Twin Towns Services Club Redevelopment (MP06_0237)

ATTACHMENT 1: CAR PARK DESIGN OPTIONS FOR CONSIDERATION

MEETING MINUTES

SUBJECT : **Twin Towns Services Club Expansion Car Park Issues**

ATTACHMENT 1

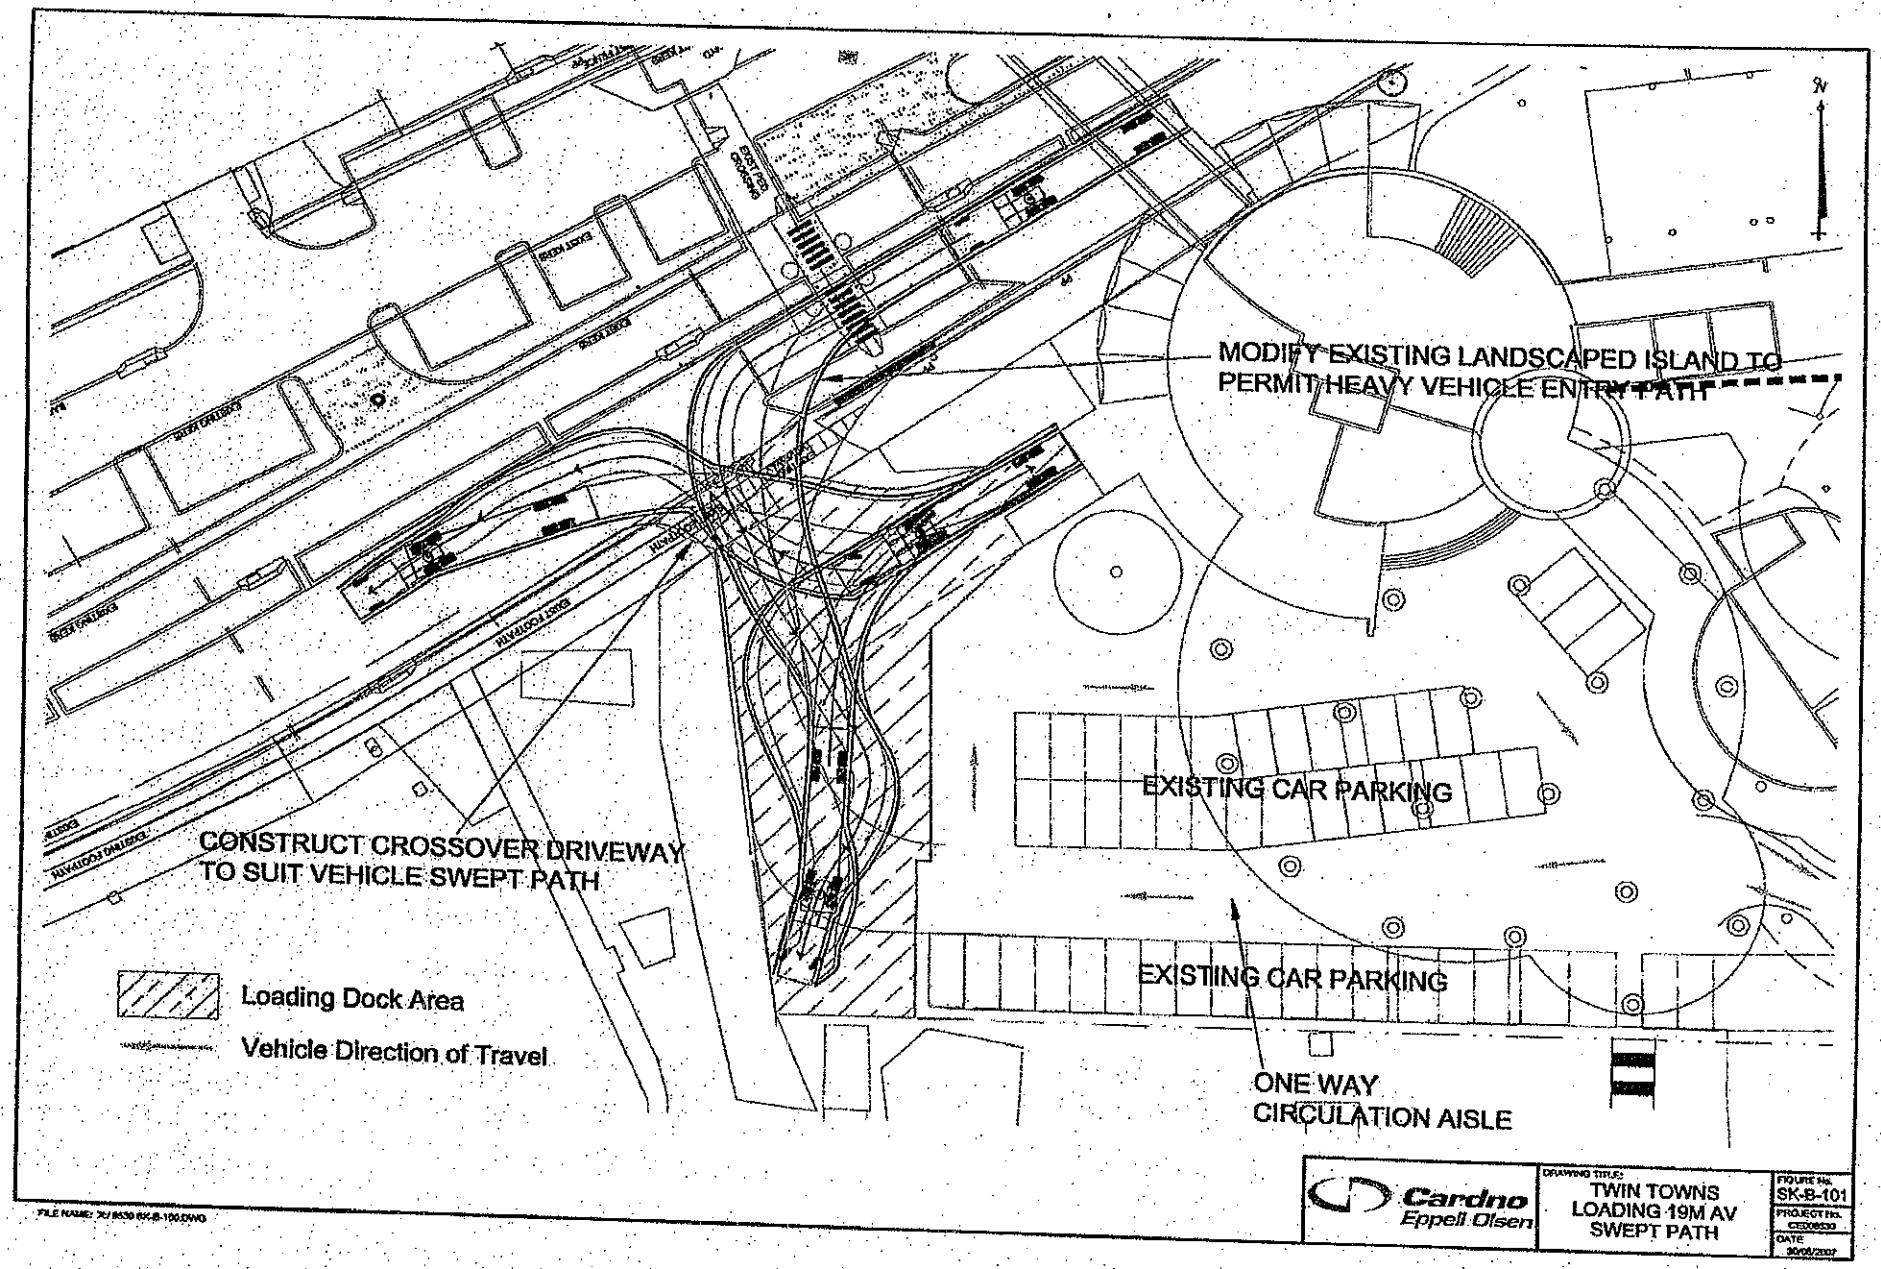
The access is proposed to be widened to allow articulated vehicles to enter and leave the site in a forward direction. Attachment 1 is taken from the Traffic Report and shows the extent of work required and the impact on Councils existing traffic islands.

The report also addresses potential conflict with the 'zebra' crossing on Wharf Street. It is noted the alterations required to the streetscaping island are clear of the crossing and will be safer then the current practice of trucks reversing from the site onto Wharf Street which is a safety concern (and has not been approved by Council).

The proposal as contained in the submitted document is considered satisfactory and could be approved subject to conditions requiring the following:

a) Work to be in accordance with TSC Access to Property Policy;

b) Detailed design plan to be prepared showing details of modifications to Councils infrastructure in Wharf Street and be approved be Tweed Shire Council prior to construction;

c) Any modification to the 'mural' wall to achieve sight lines specified in AS 2890 are to be shown on the Plan required in (2);

d) The physical barrier proposed between the loading dock area and the car park area be constructed prior to occupation.

ATTACHMENT 2

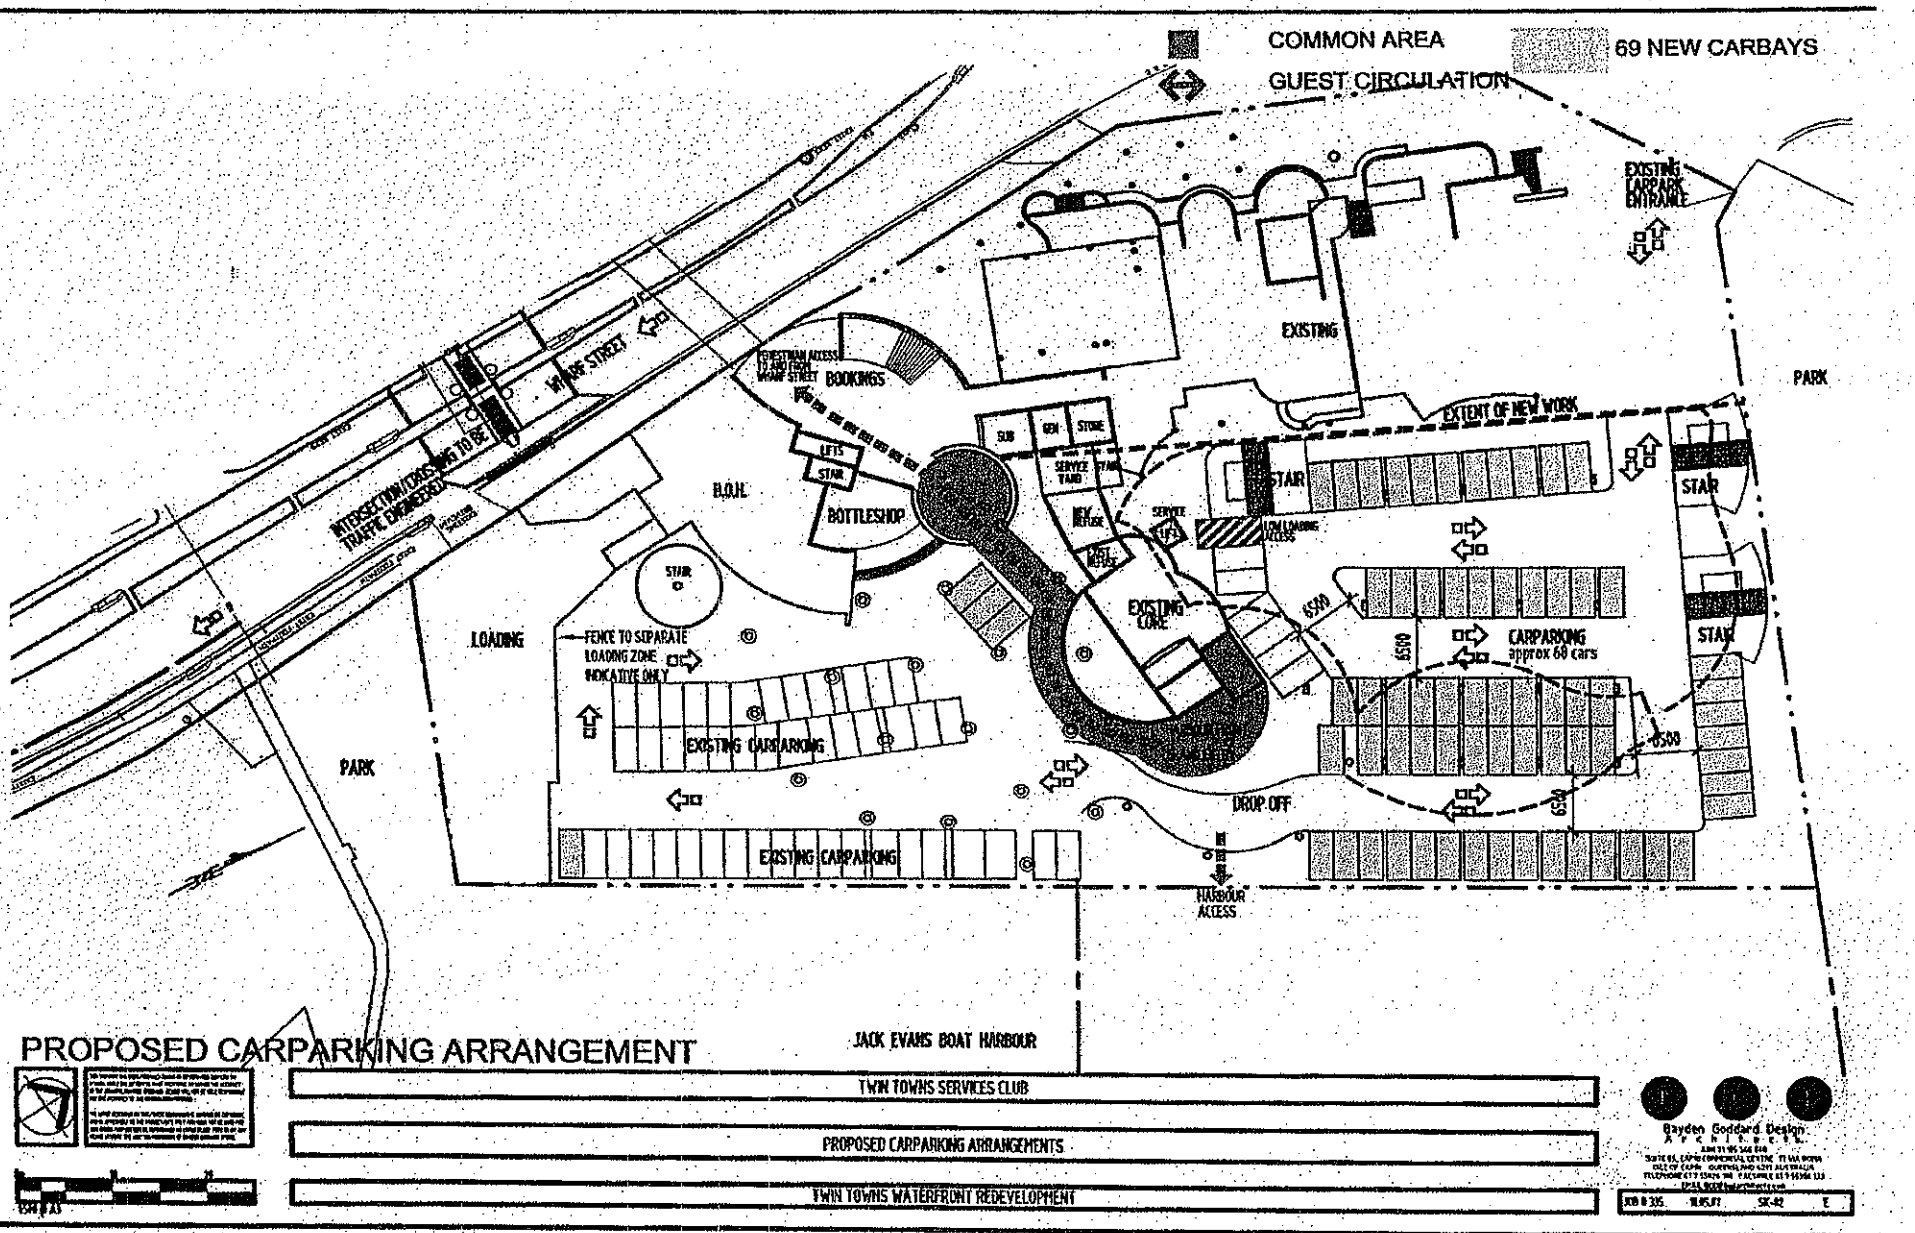
Attachment 2 shows the pedestrian corridor location within the car park.

The pedestrian corridor shown in Attachments 2 & 4 both appear to be in a location that complies with AS2890.1 and it is recommended that speed humps in accordance with Section 4.9 of AS 2890 be placed on the traffic isle either side of the 'corridor' to further ensure low speed of circulating traffic. Even without such devices the speed environment is low due to the curvilinear alignment and short aisle lengths.

Suggested consent conditions should include:

a) Sight distance must be demonstrated in accordance with AS2890.1;

b) Speed humps are required on each side of the pedestrian corridor across the traffic isle in accordance with Section 4.9 of AS 2890;

c) An alternative pavement 'colour' or surface be used between the speed humps;

d) Adequate lighting in accordance with AS 1158 streetlighting to be provided.

ATTACHMENT 3

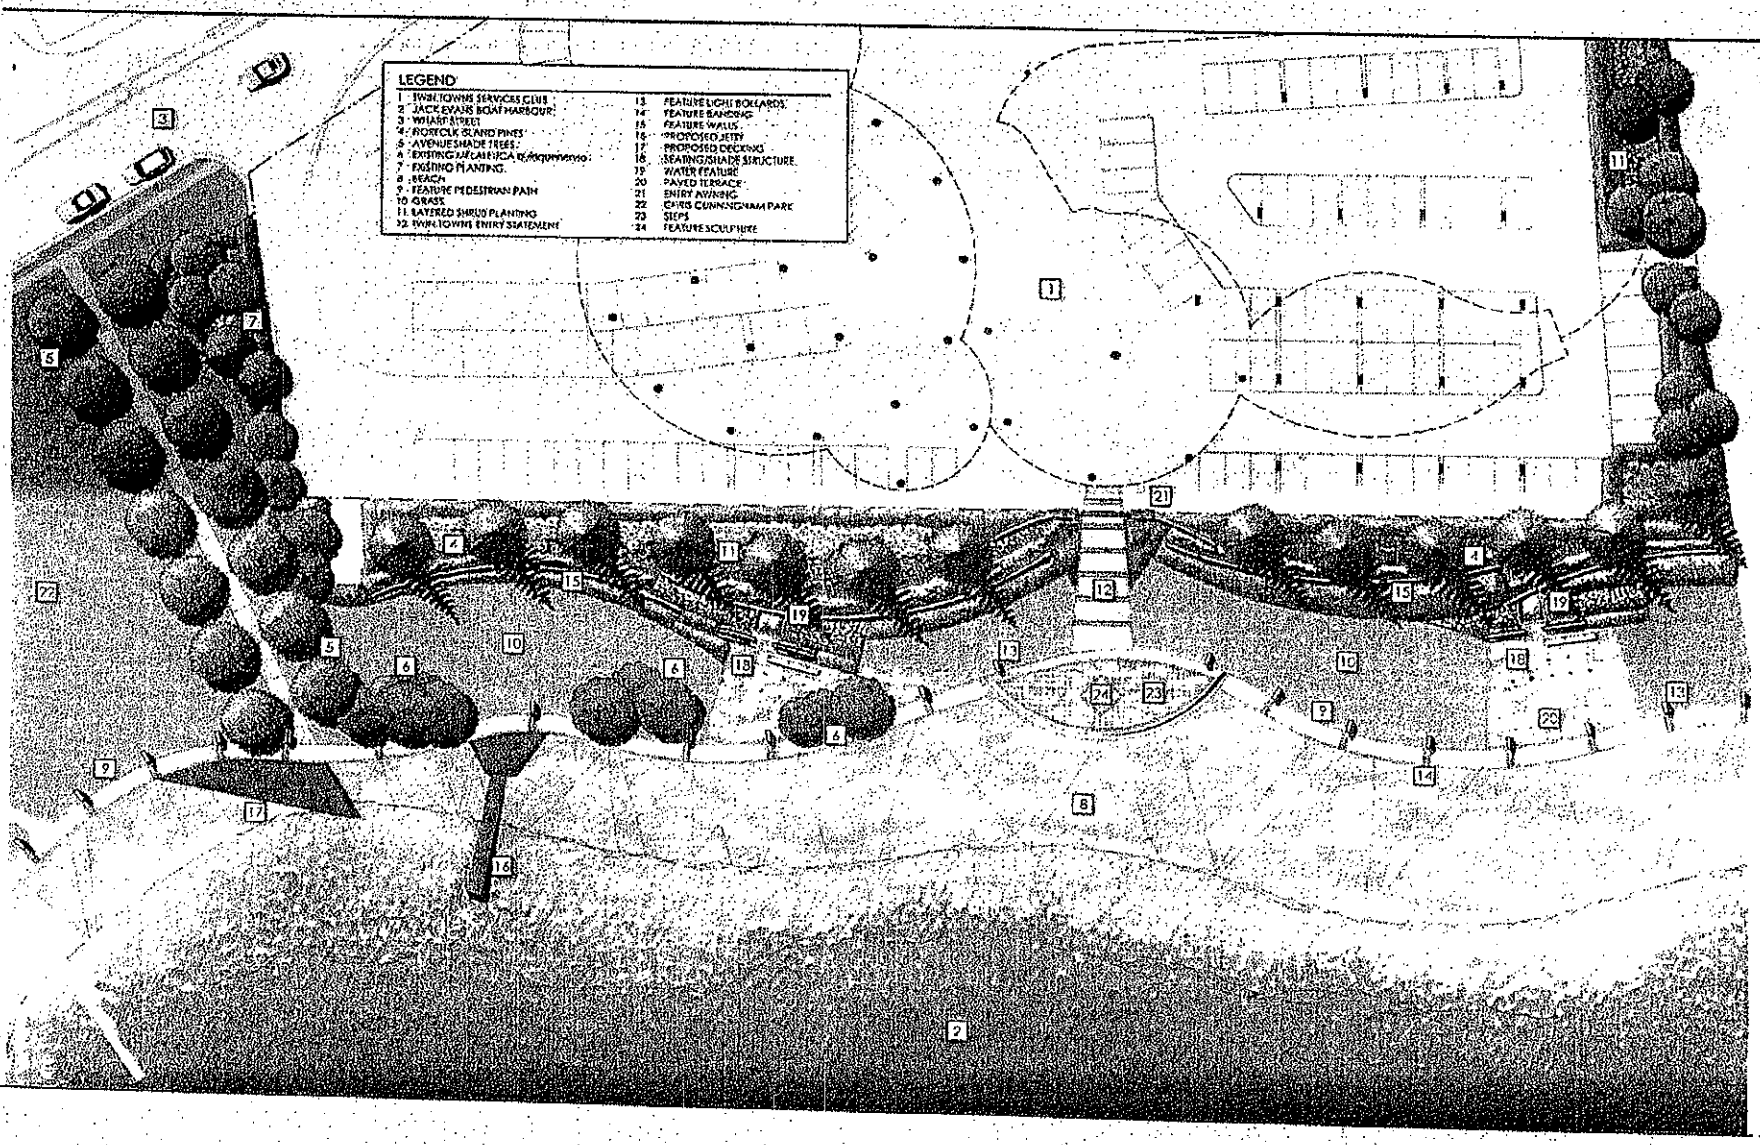
The pedestrian movement from the Parkland to the ground floor foyer is required to link with the pedestrian access shown on the Jack Evans Masterplan and shown in the submission and attached as Attachment 3.
